# APPROVED MINUTES

## March 20, 2014 Standards Committee Meeting

RE: Minutes from the March 20, 2014 Standards Committee Meeting

REVISION TO STANDARD SPECIFICATIONS, SPECIAL PROVISIONS AND DRAWINGS  
REVISION TO STANDARD DRAWINGS

## 802-SNGP-01 SIGN PLACEMENT WIDE FLANGE SIGN SUPPORT (REVISED DRAFT)

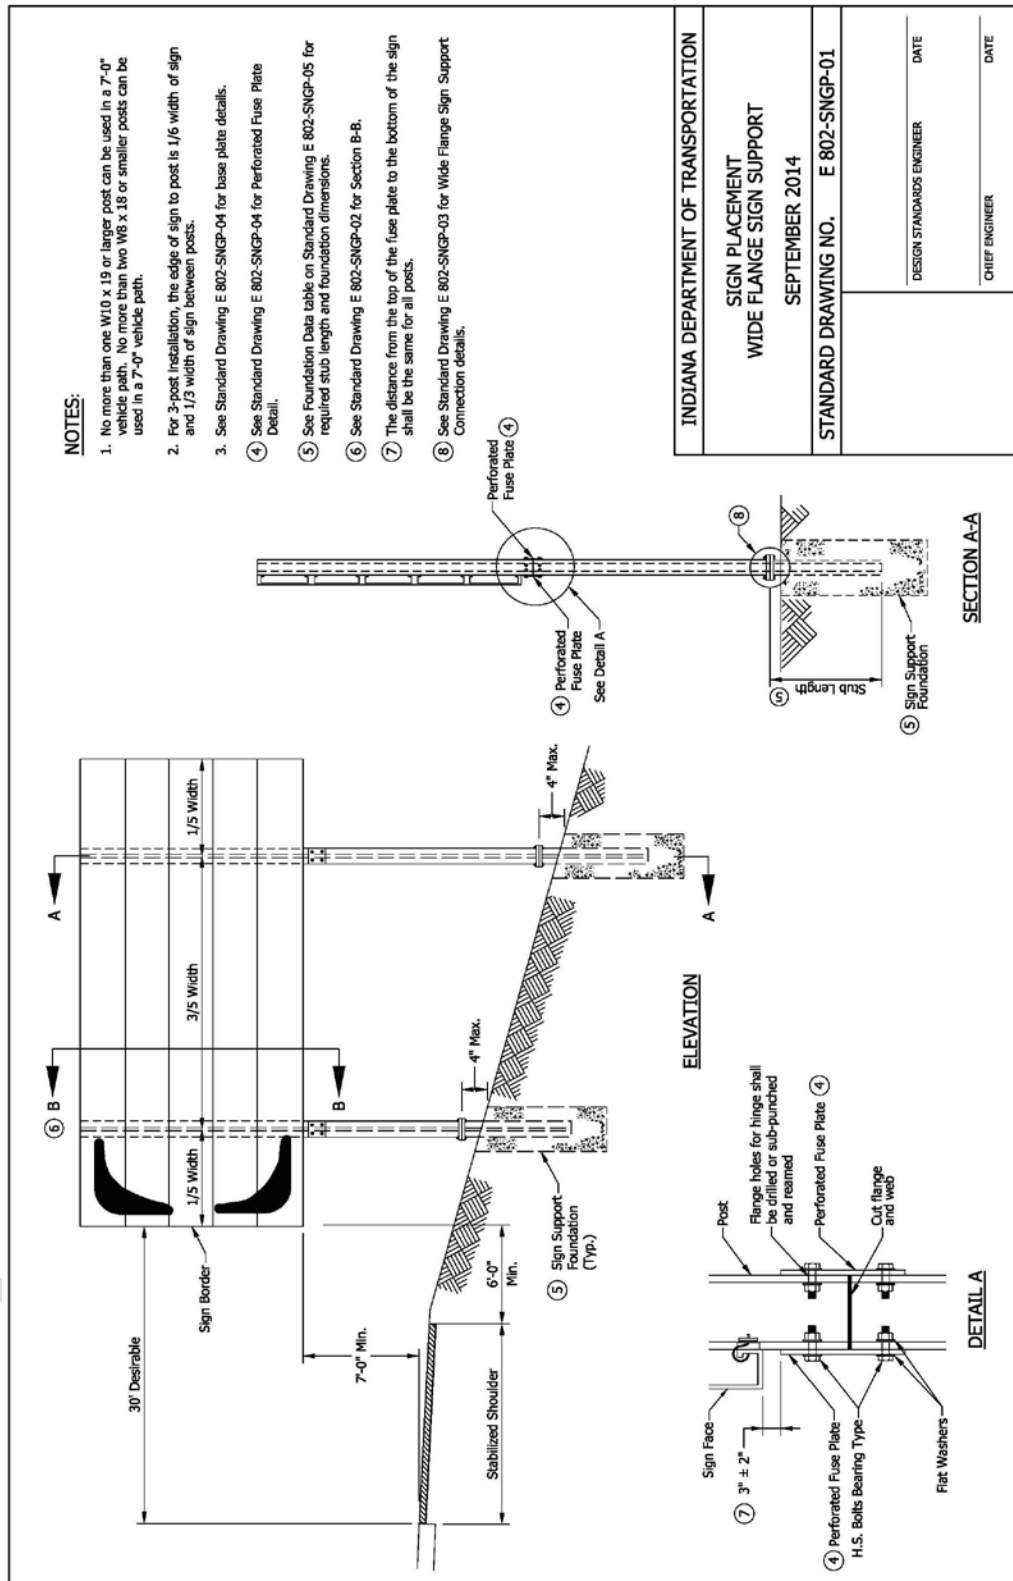
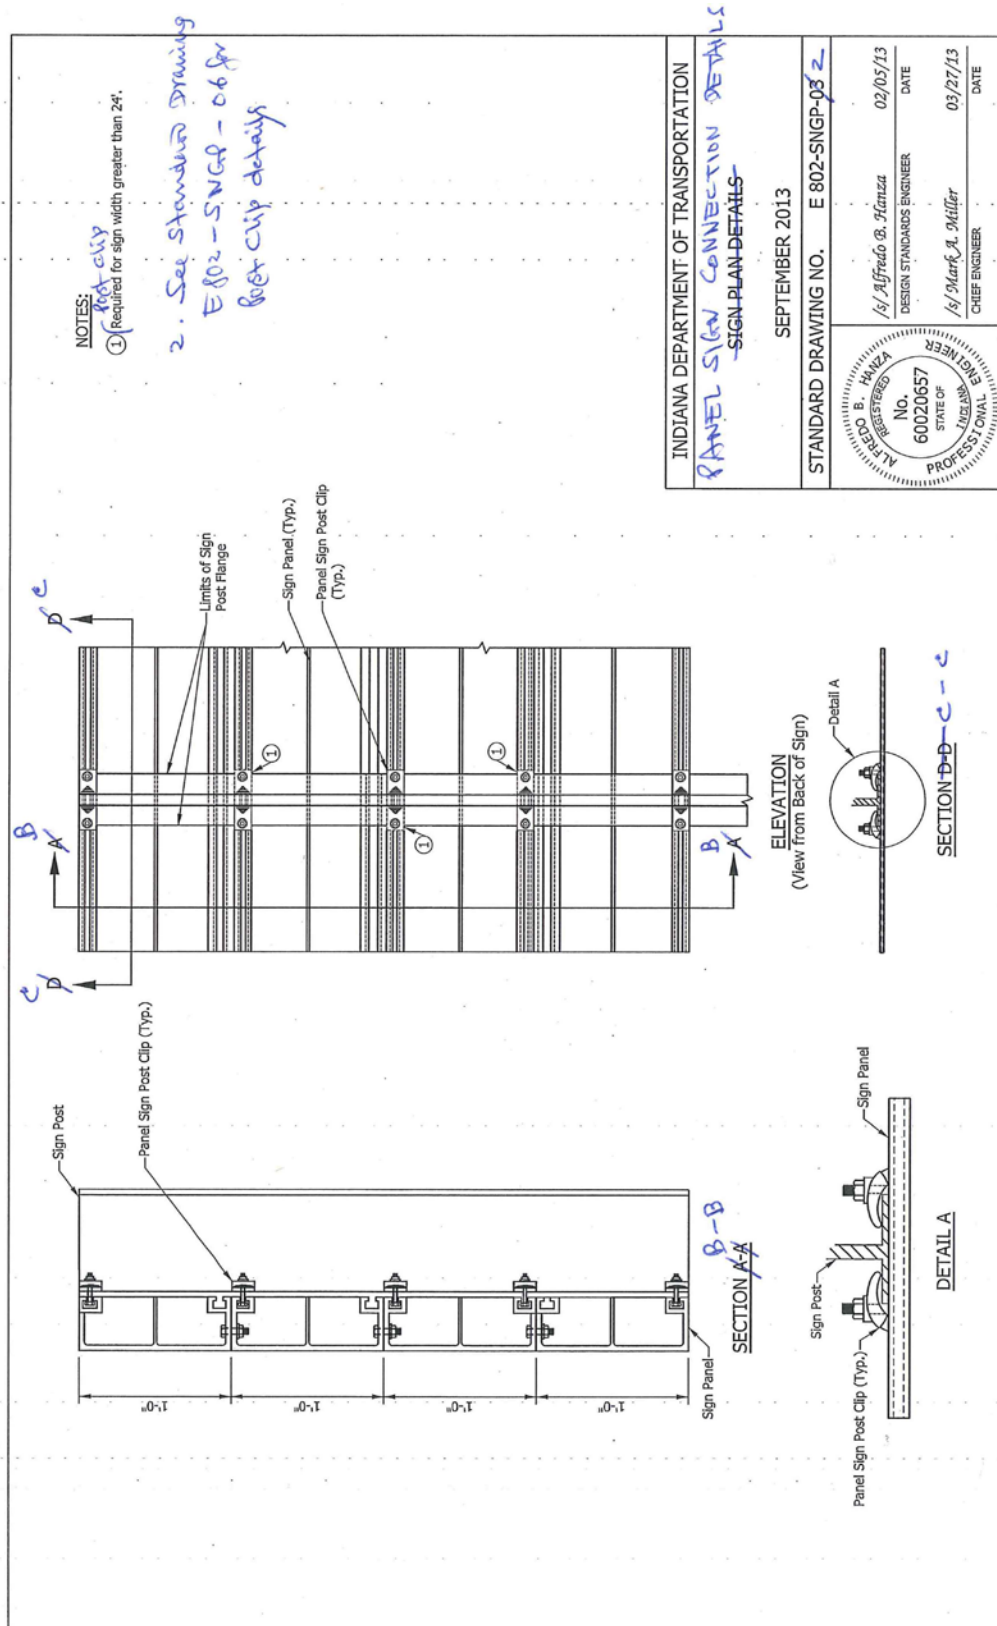
PROBLEM(S) ENCOUNTERED: Standard Drawings 802-SNGP-13 and 802-SNGP-14 showing Sign Placement for divided highway intersections with medians 30 ft or wider do not include the ONE WAY signs in the median that are required by the 2011 IMUTCD.

Mr. Miller asked about note 1 on sheet E 802-SNGP-01, concerning the distance between posts. Mr. Pankow offered clarification that there are to be no more than two posts within 7 ft of each other. Mr. Miller asked if that information should be in the design manual, instead of on the standard drawing, and if designed correctly, that note would not be necessary. Further discussion ensued concerning sign design and layout and placement. Following the discussion, it was determined to leave the note with adding a word "vehicle".

DISCUSSION: This item was introduced and presented by Mr. Boruff who stated the reasoning behind these standard drawing revisions, as shown on the proposal sheet. Mr. Boruff further explained some of the drawing revisions shown. Mr. Garg handed out revised drawings for E 802-SNGP-04 and -05 showing plate and shim details which clarify the washer type and thickness. Also revised is drawing E 802-SNGP-01, which clarifies Note 1 regarding the 7 ft wide vehicle path.

INDIANA DEPARTMENT OF TRANSPORTATION	WIDE FLANGE SIGN SUPPORT DATA TABLES	SEPTEMBER 2014	STANDARD DRAWING NO. E 802-SNGP-05
			DESIGN STANDARDS ENGINEER
			DATE
			CHIEF ENGINEER
			DATE

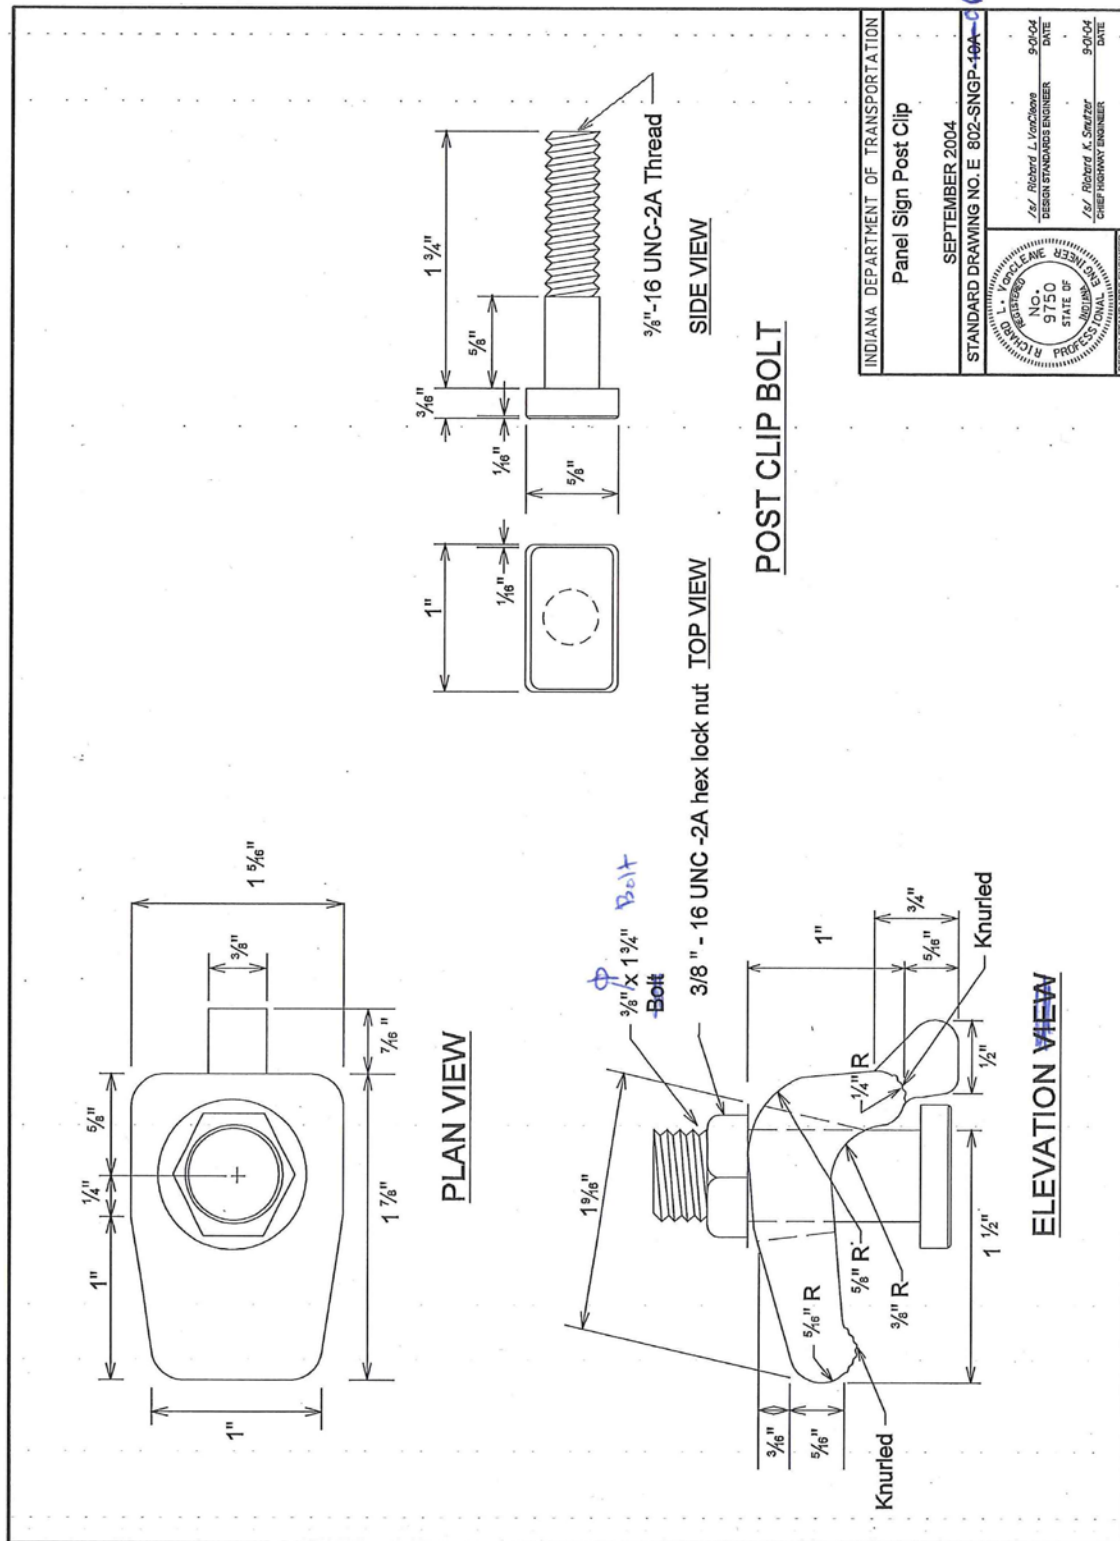
Condense 802-SNGP-05 thru -07 into one drawing.

ADD PERFORATED FUSE PLATE DATA TABLE HERE FROM ST. DR. 802-SNGP-06

ADD FOUNDATION DATA HERE FROM ST. DR. 802-SNGP-07

Move this table to ST-DW. 802-SNGP-05

Move this table to ct. 802-SNGP-05

802-SNGS-12 WIDE FLANGE POST SELECTION TABLE (WITH MARKUPS)

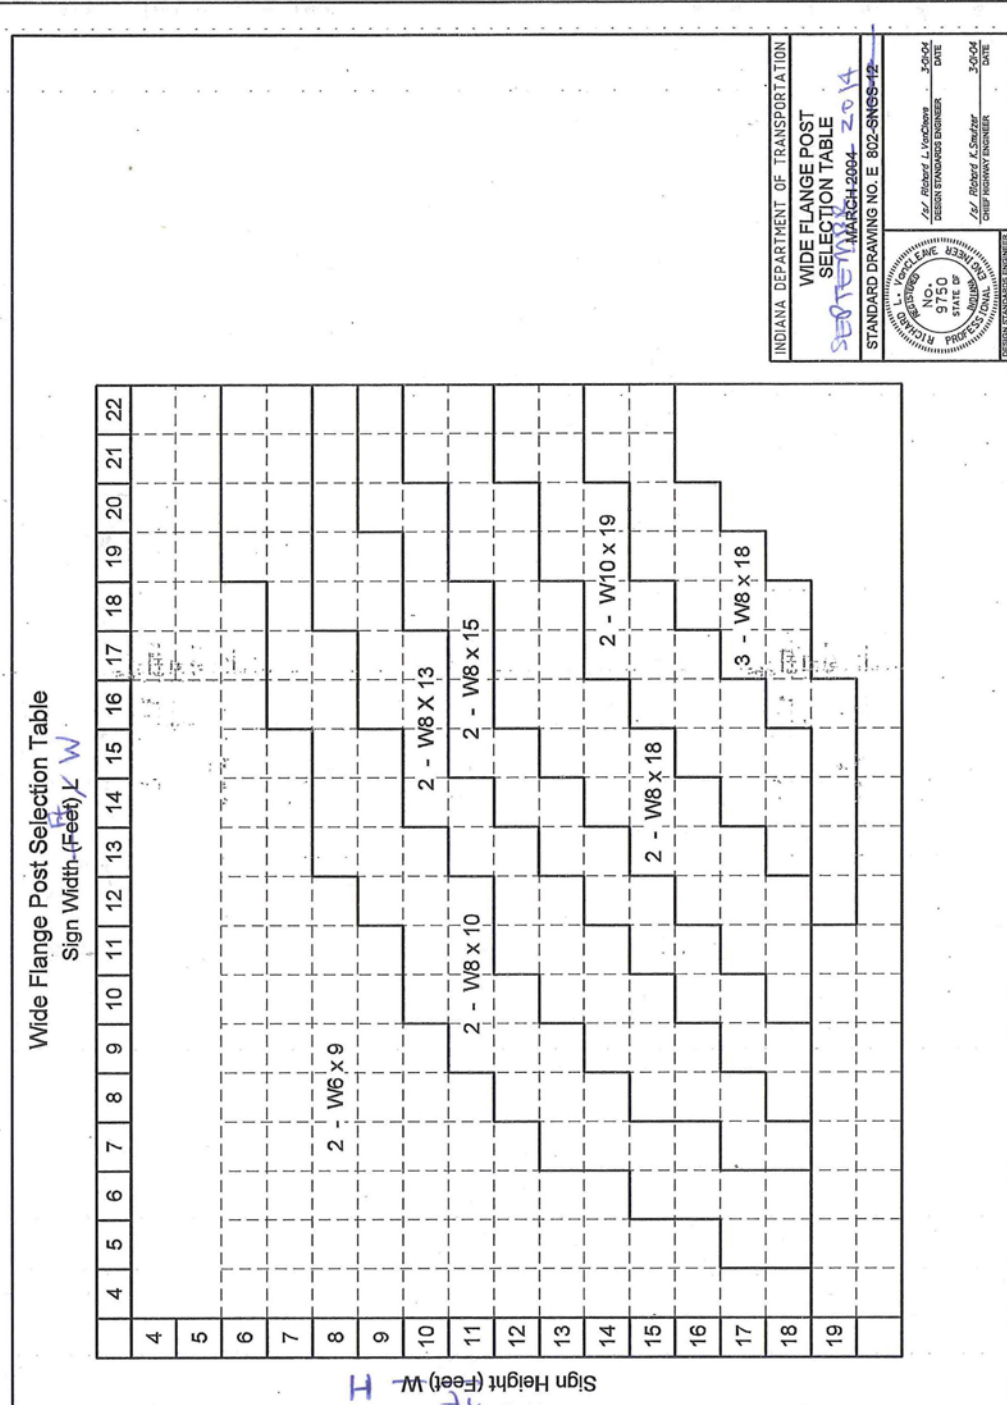
Lastly, 802-SNGP-11 thru -14 concern sheet signs only while the remainder of the drawings in the series detail panel signs and panel sign (wide flange) supports. At the same time 802-SNGS-12, containing the wide flange support selection chart, is the only panel sign related drawing in the 802-SNGS series which otherwise consists of sheet sign details.

Move 802-SNGS-12 to the 802-SNGP panel sign series.

802-SNDH-01 SIGN PLACEMENT DIVIDED HIGHWAY INTERSECTION MEDIAN WIDTH < 30 FT (DRAFT)

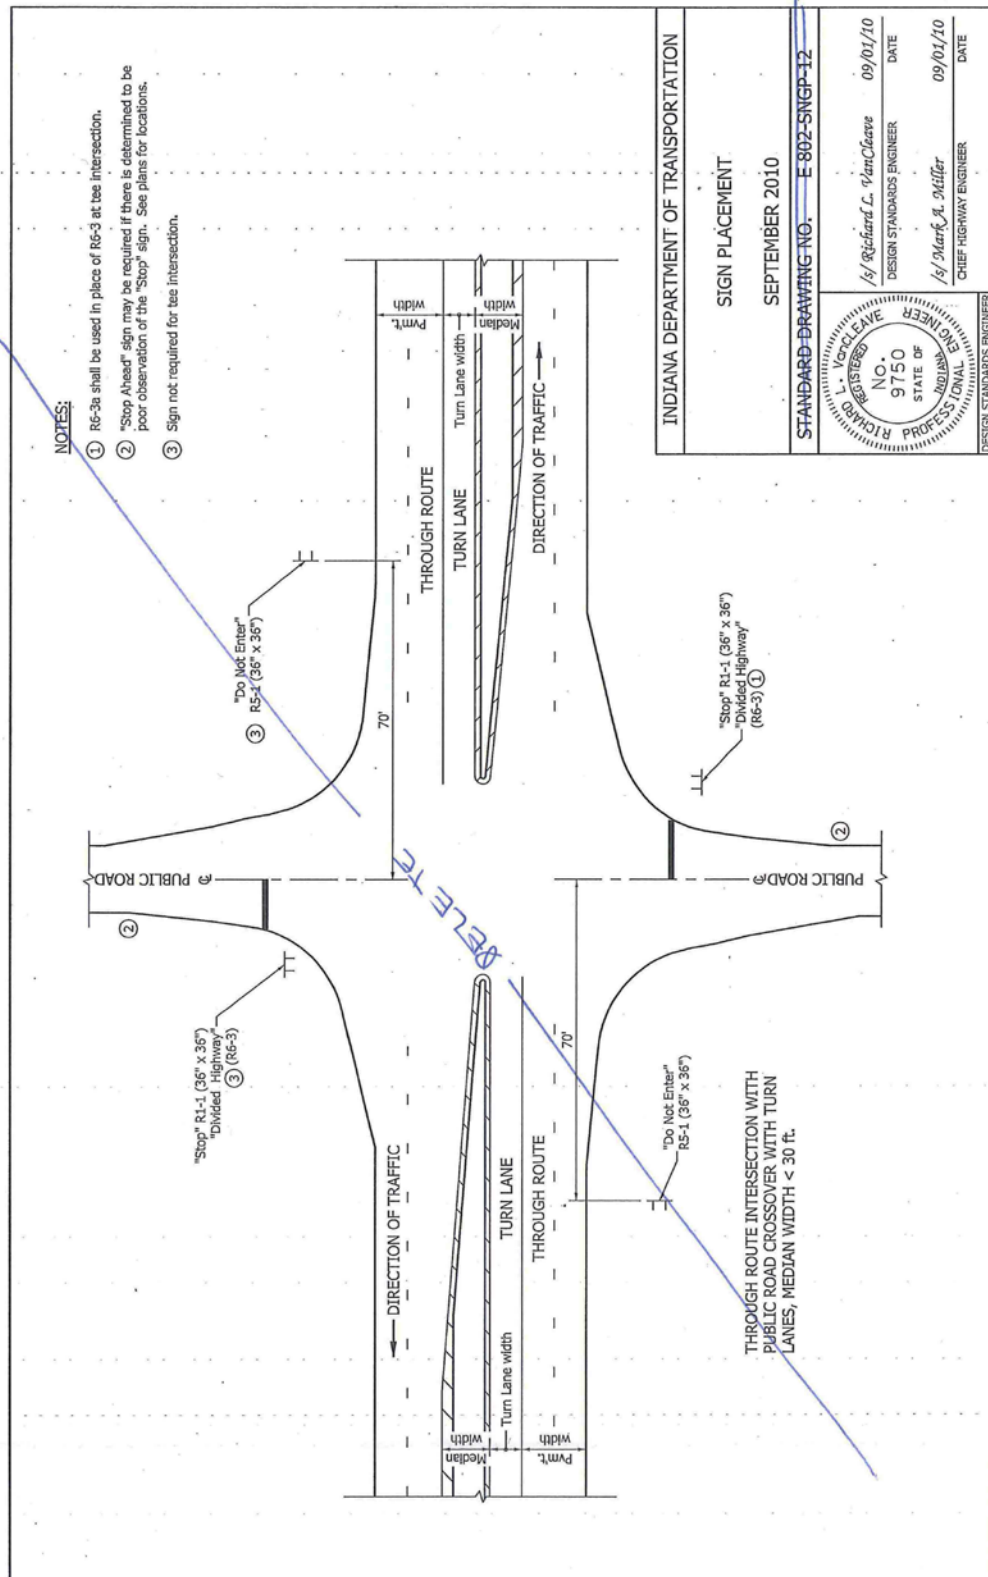
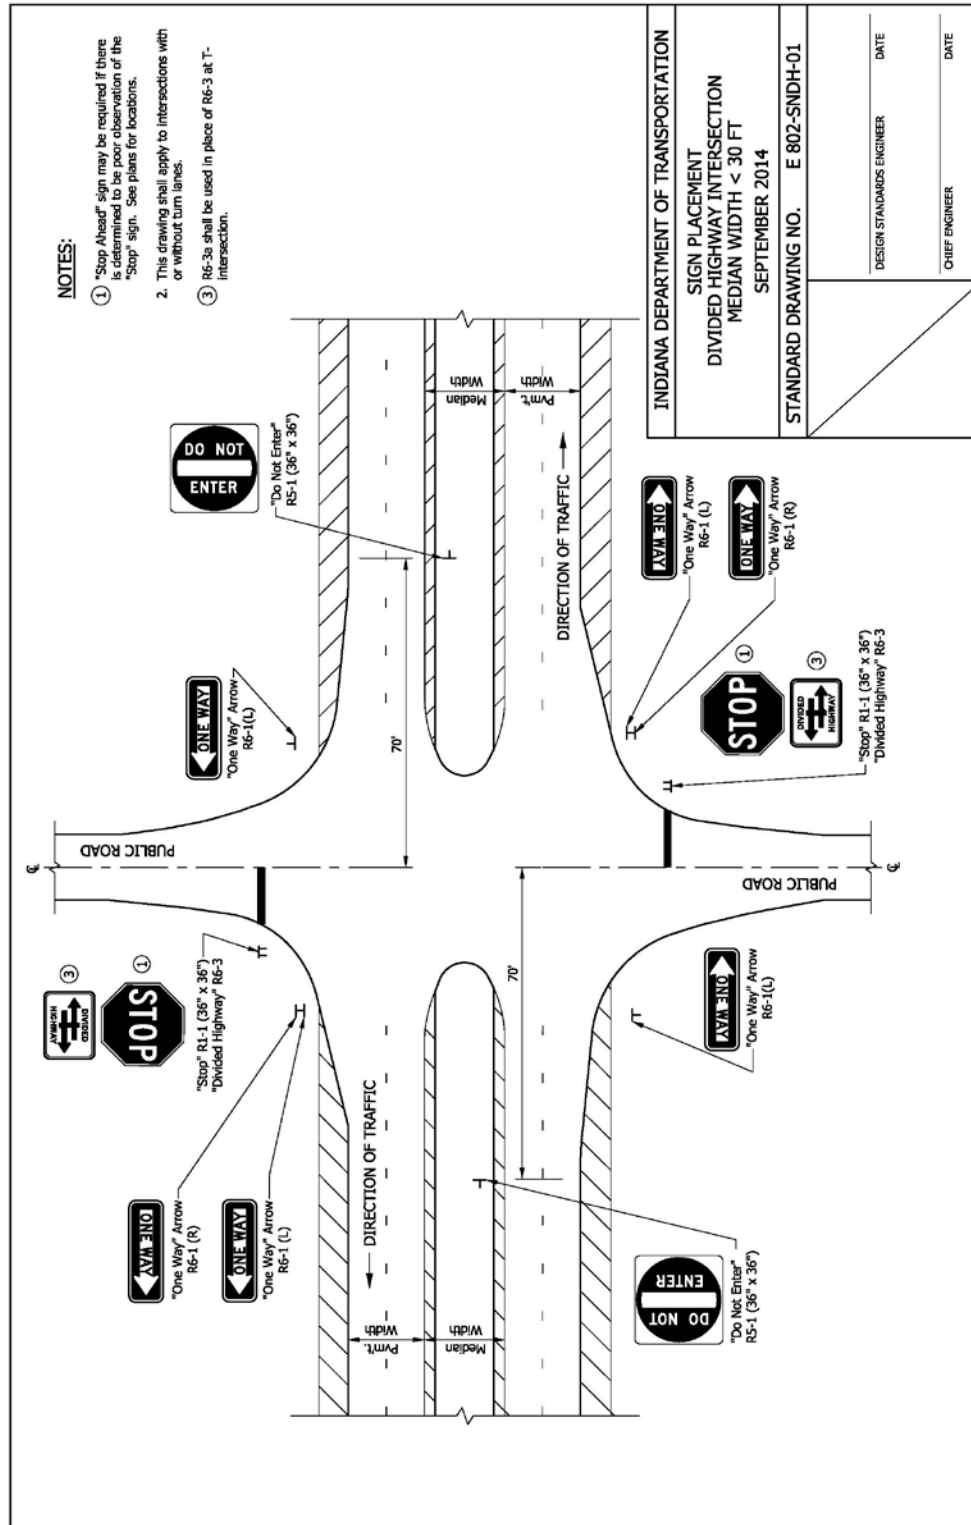
1. 802-SNGP-11 and 802-SNGP-12 show identical signing
2. 802-SNGP-13 and 802-SNGP-14 also show identical signing
3. 802-SNGP-05, 802-SNGP-06, 802-SNGP-07 which show sign post and foundation data can be condensed.

PROPOSED SOLUTION: Revise Standard Drawing 802-SNGP-13 and place in a new series, 802-SNDH. Also move 802-SNGP-11 into the new series and eliminate 802-SNGP-12 and 802-SNGP-14.
